**RE: 7201 Montgomery Blvd NE Church of Christ**  
**Grading Plan Engineer's Stamp Date: 12/13/2018**  
**Hydrology File: F19D003A**

## DRAINAGE REPORT REV 1

### **Montgomery Church of Christ** 7201 Montgomery Blvd NE, Albuquerque, NM 87109

**RE: 7201 MONTGOMERY BLVD NE CHURCH OF CHRIST  
GRADING PLAN ENGINEER'S STAMP DATE: 12/07/2018  
HYDROLOGY FILE: F19D003A**

ENGINEER'S SEAL 	MONTGOMERY CHURCH OF CHRIST 7201 MONTGOMERY BLVD. NE	DRAWN BY BF
	GRADING PLAN	DATE 12/11/18
		2016037_GRB
		SHEET # C3
		JOB # 2016037

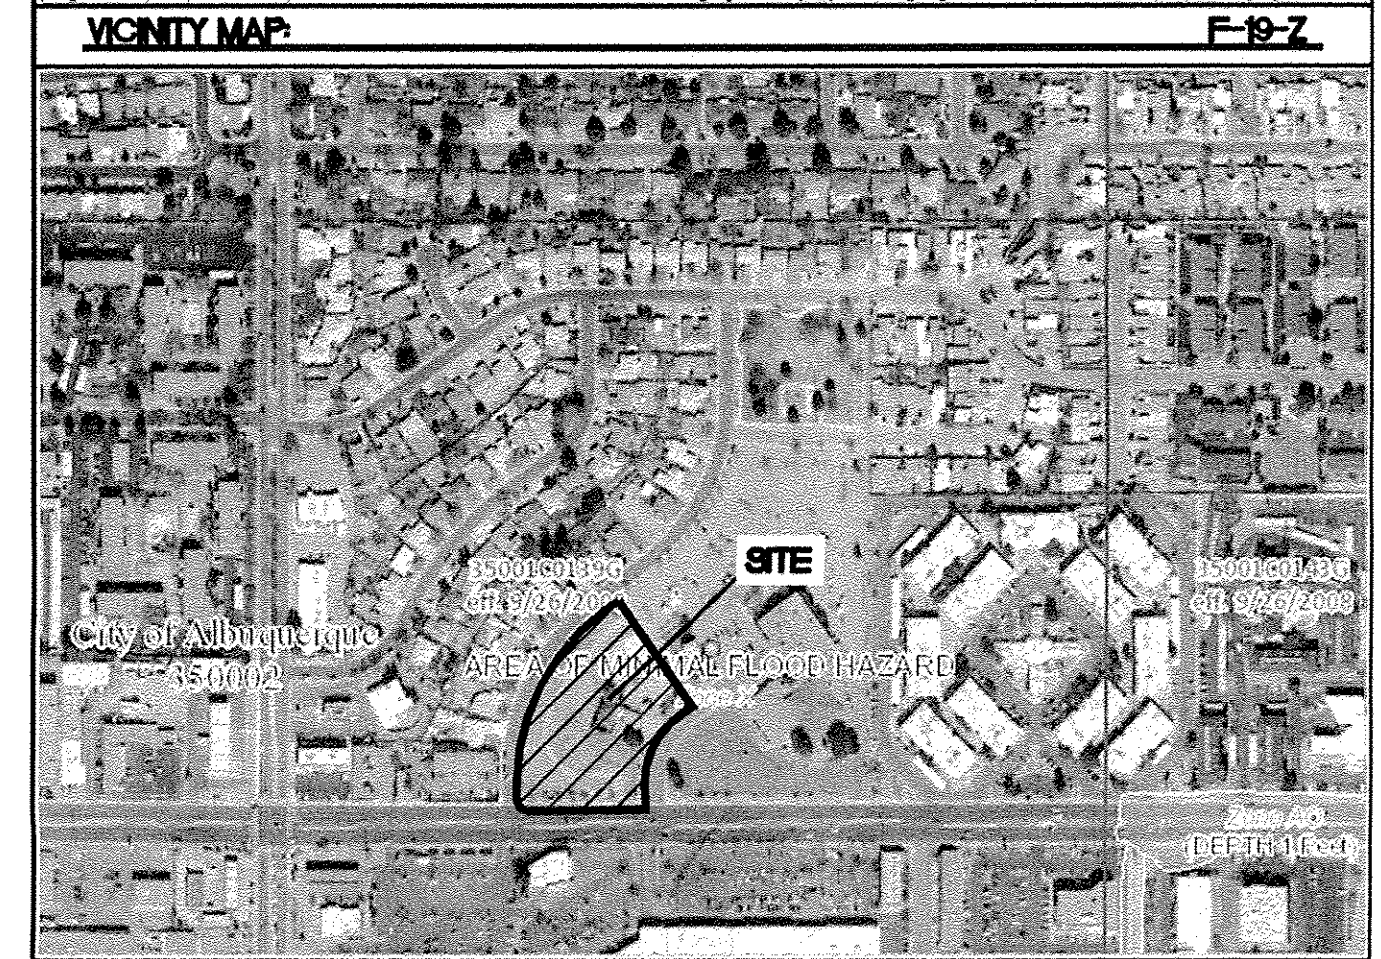
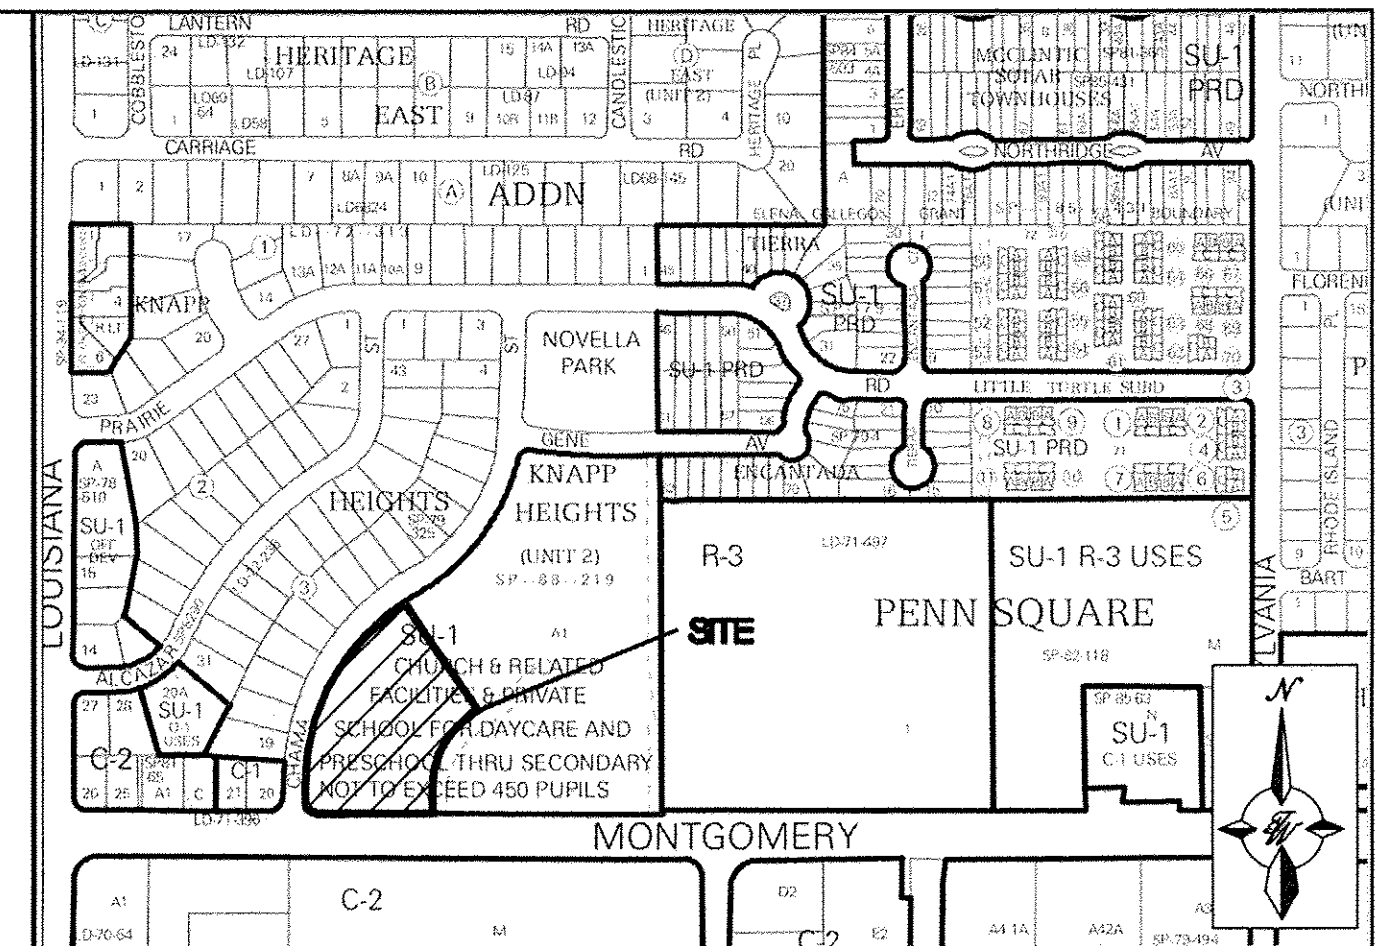
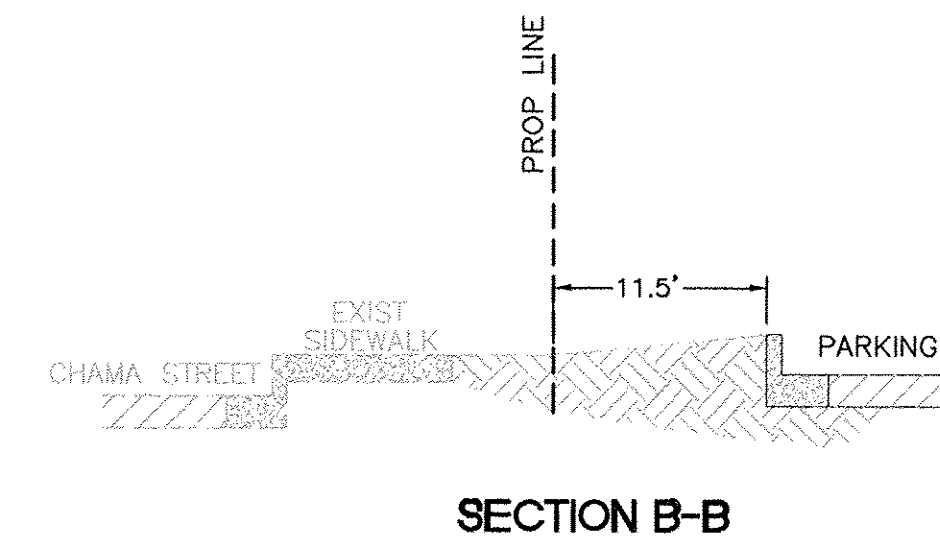
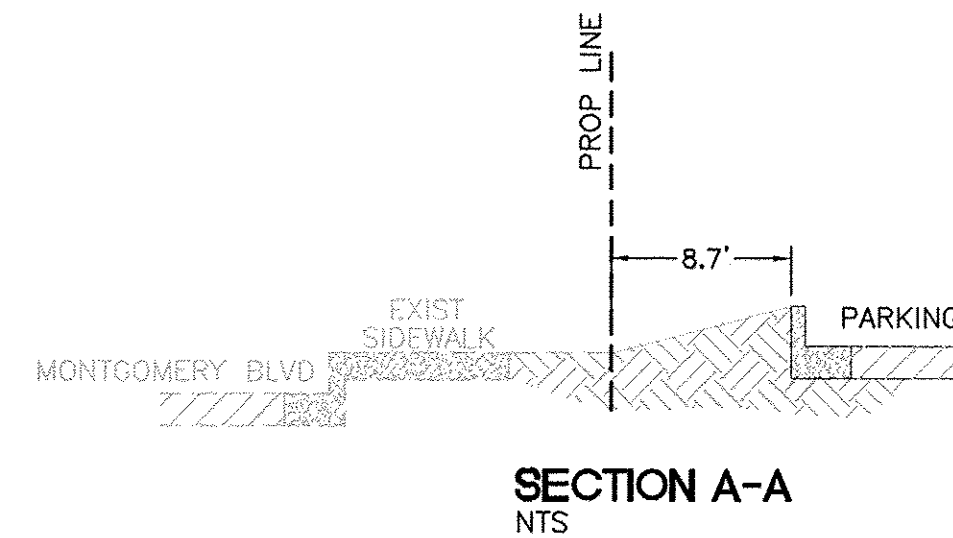
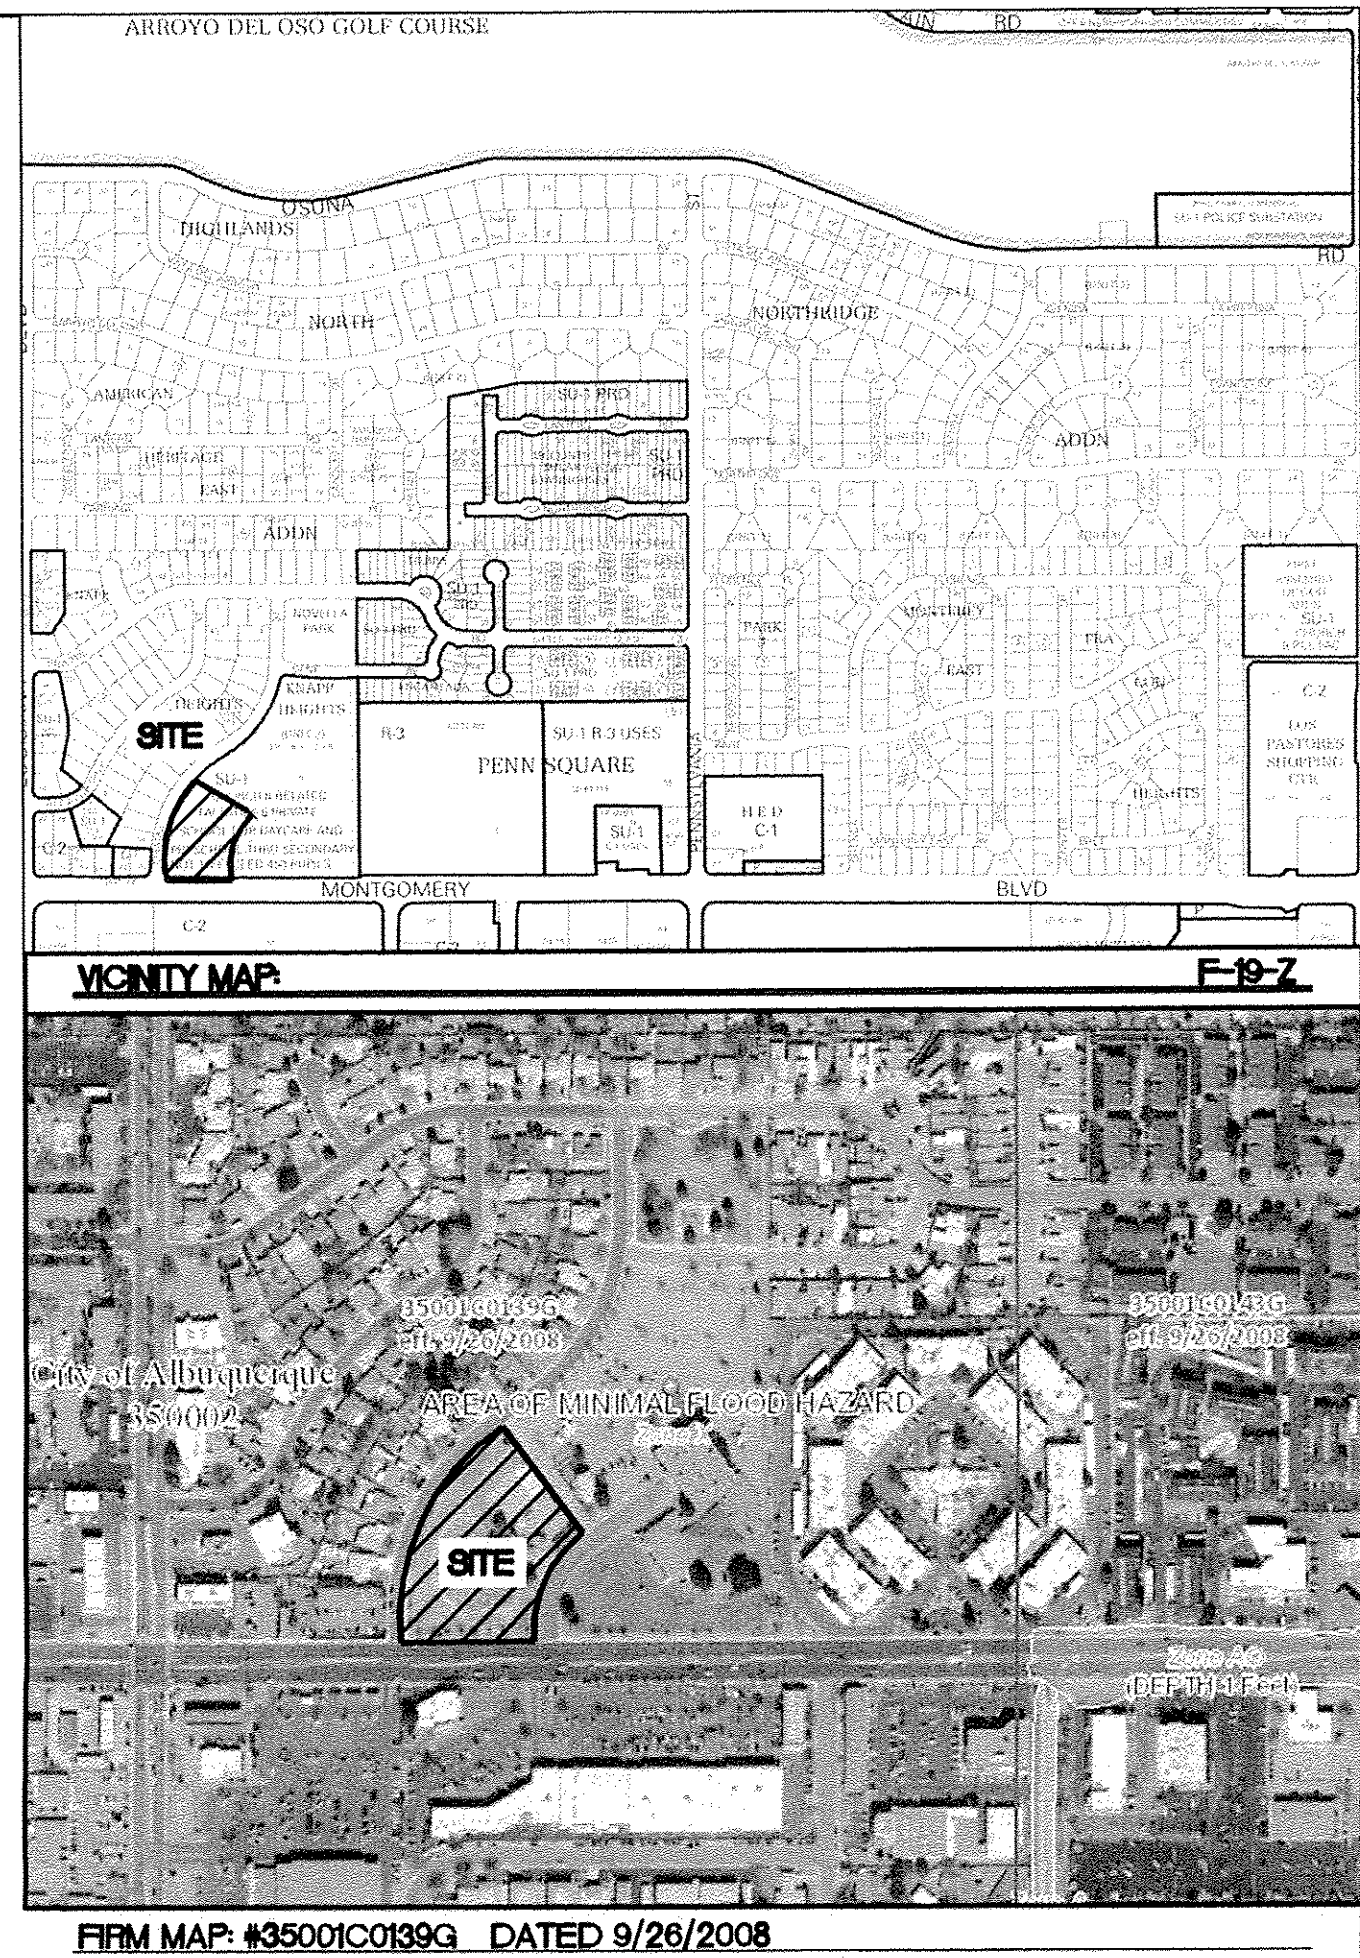
1. Add standard SO-19 note available on the hydrology web page.  
**Response:**  
**The standard SO-19 notes were added to the Grading Plan.**
2. There are two sets of contours inside the ponds making the plan hard to read. Please revise so the pond contours are legible.

**Response:**  
**The pond contours were amended to clearly show the contours.**
3. The drainage rundowns into the ponds and the sidewalk culverts need to be sized using both the weir equation and normal depth, whichever is the more limiting. At 8" depth they have capacity for about 1.25 cfs per foot width. The width of the rundowns and the sidewalk culverts needs to be increased to provide 100 year capacity.

4. Please provide normal depth calculations for sizing the curb height in the parking lot. Curb heights in the parking lot should be specified on the plan and curb with gutter recommended where the parking lot curb is used to collect and convey the drainage.

**Response:**  
**The sidewalk culverts and curb openings were checked for the weir equation and modifications made to increase their capacity as required to convey the design flow. The 2x sidewalk culverts capacity was checked to confirm it can convey the design flow (13.6 cfs>11.6 cfs).**

**Response:**  
**The proposed curb and gutter extents is detailed on the site plan. The capacity of the curb and parking lot was checked to ensure it has adequate capacity to convey the design flows. Included in the revised report is the calculations confirming the capacity (18.53 cfs>8.41 cfs).**

DRAWN BY  
BF  
DATE  
12/11/18  
2016037—DRAINAGE  
DEVELOPED  
SHEET #  
C4  
JOB #  
2016037

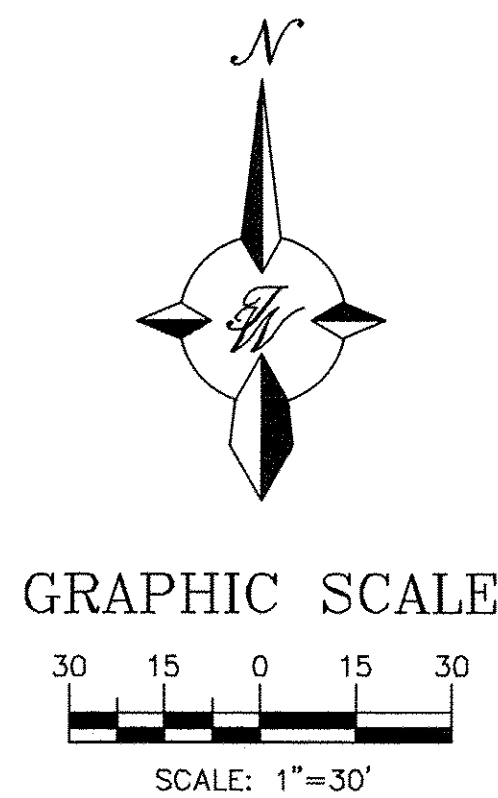
5. The water quality precipitation depth in the calculations on the plan (Sheet C-2) needs to match the depth in the report, 0.26" for re-development.

**Response:**  
**The formula used to calculate the Stormwater Quality Volume to be retained on site is  $= (.44" - 0.1") * 1/12 * I * 43,560$  where I is the impervious area in acres. This is detailed on the Drainage Sheet and in the report under section 'SWQV Management'.**
